ULC 524:2019 ERRATA!

Corrected Clause in ULC 524:2024

Figure 52.2
Example of Supporting Field Devices Serving Fire Suppression System Devices

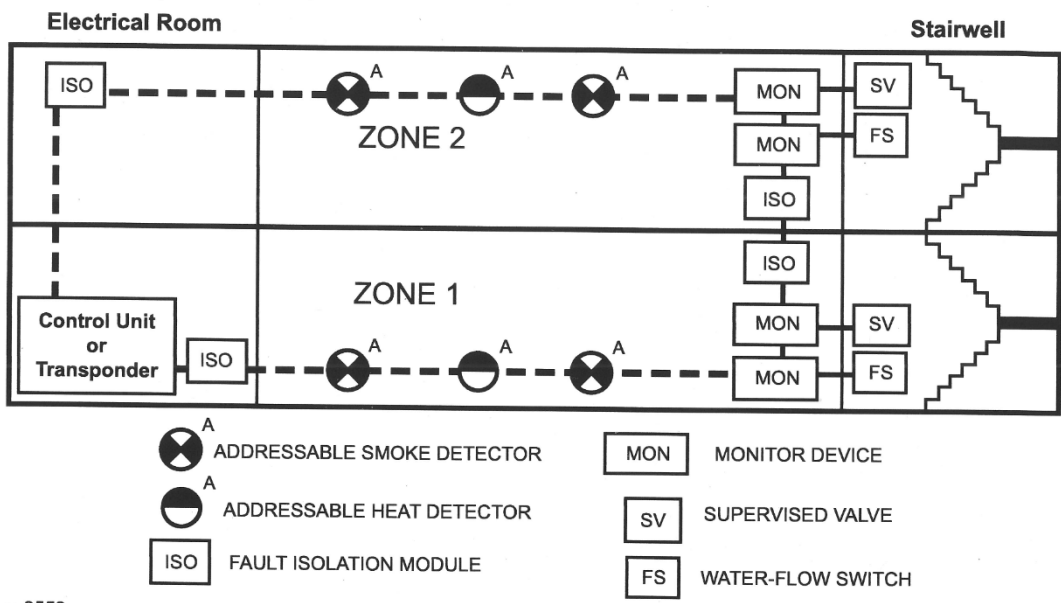
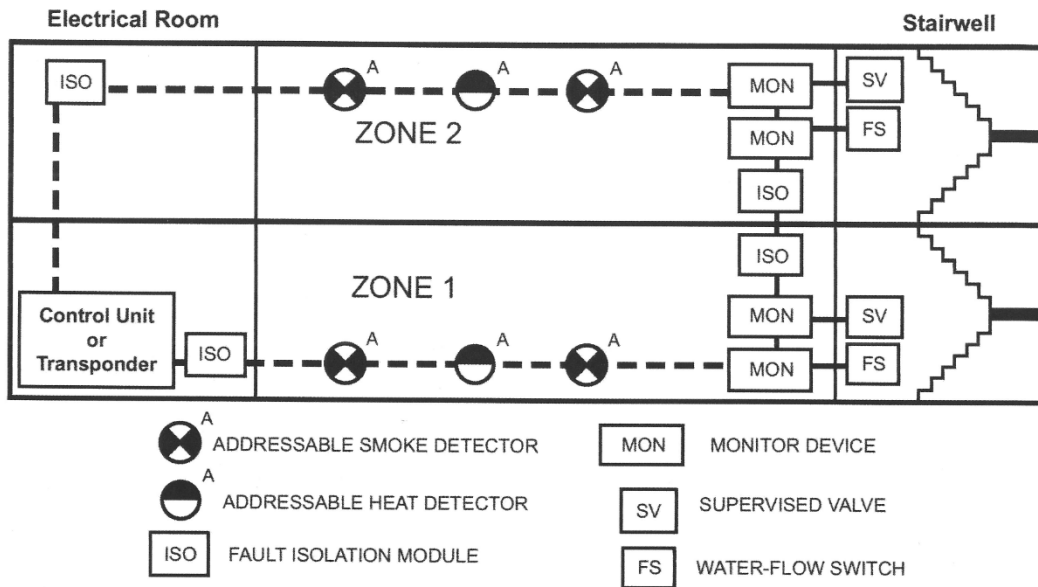
52.3.13 Supporting field devices not installed in fire protection equipment rooms (e.g., sprinkler and fire pump rooms) and not installed in exit stair shafts shall be installed in the same floor area served by the fire suppression system devices. Refer to Figure 52.2, Example of Supporting Field Devices Serving Fire Suppression System Devices.

NOTE: Phrase in **RED** is removed in ULC:524:2024.

53.3.13 Supporting field devices not installed in fire protection equipment rooms (e.g., sprinkler and fire pump rooms) shall be installed in the same floor area served by the fire suppression system devices. Refer to Figure 53.2, Example of Supporting Field Devices Serving Fire Suppression System Devices.

Note: No Change to Figure 53.2 (other than the reference number).

Figure 18-5
Example of Fault Isolator Serving Multiple Field Devices in an Exit Stair

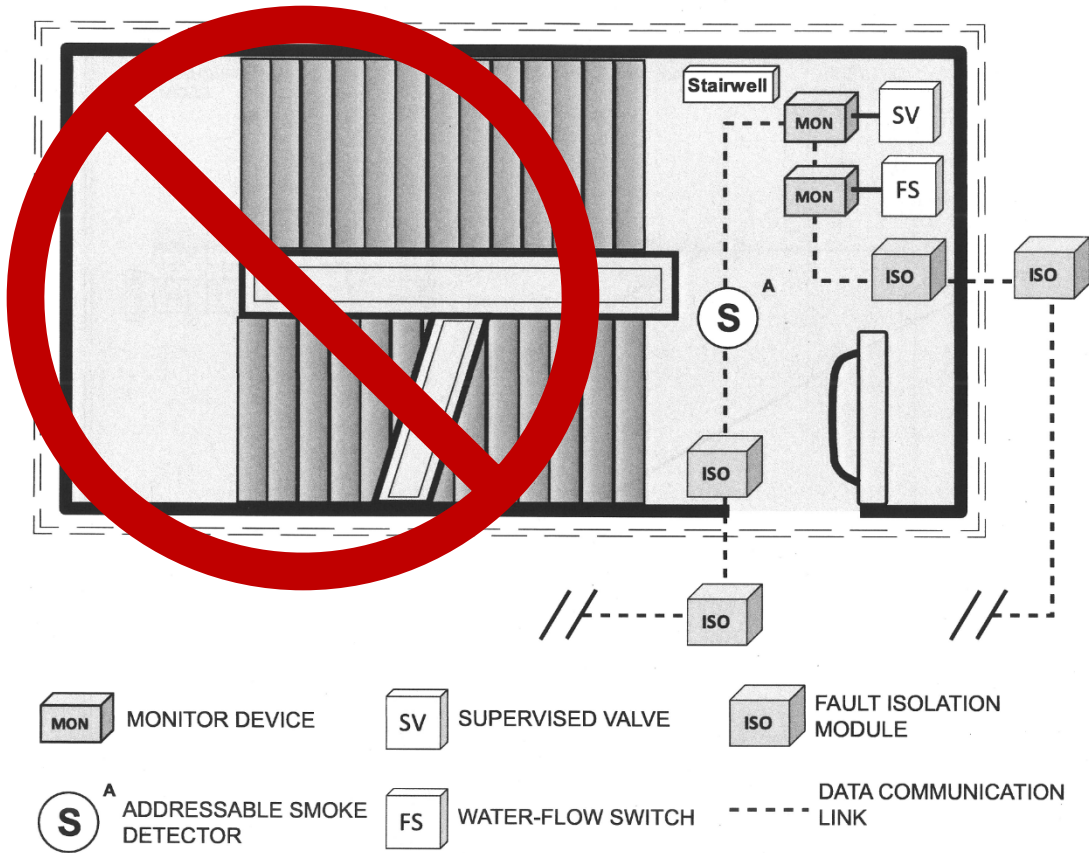
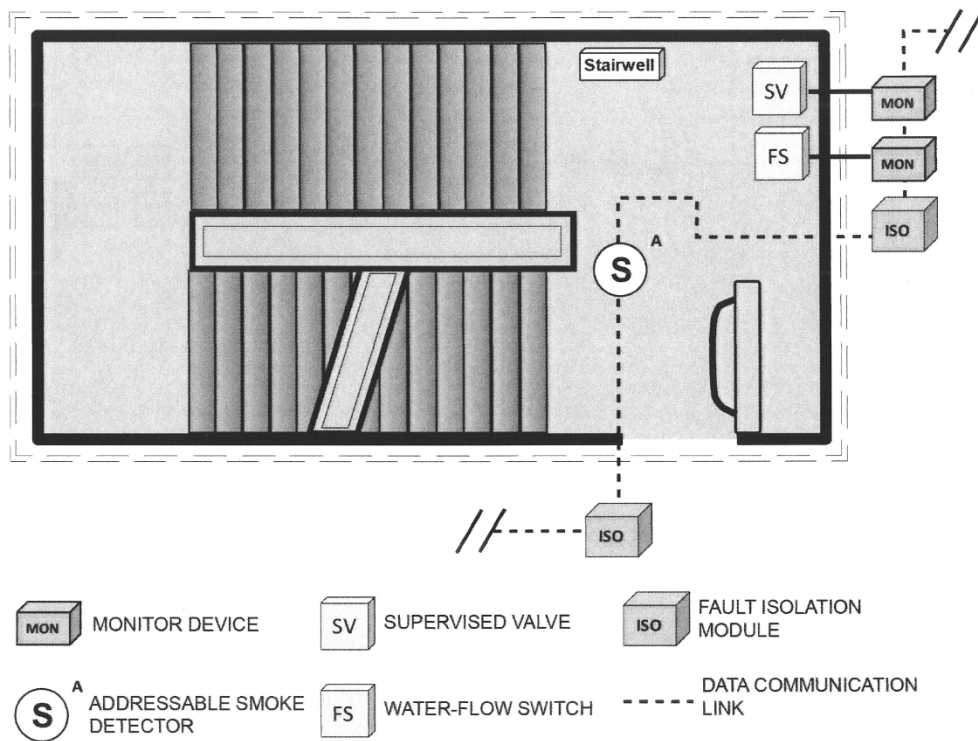
Corrected Diagram in ULC 524:2024

Figure A19.5
Example of Fault Isolator Serving Multiple Field Devices in an Exit Stair
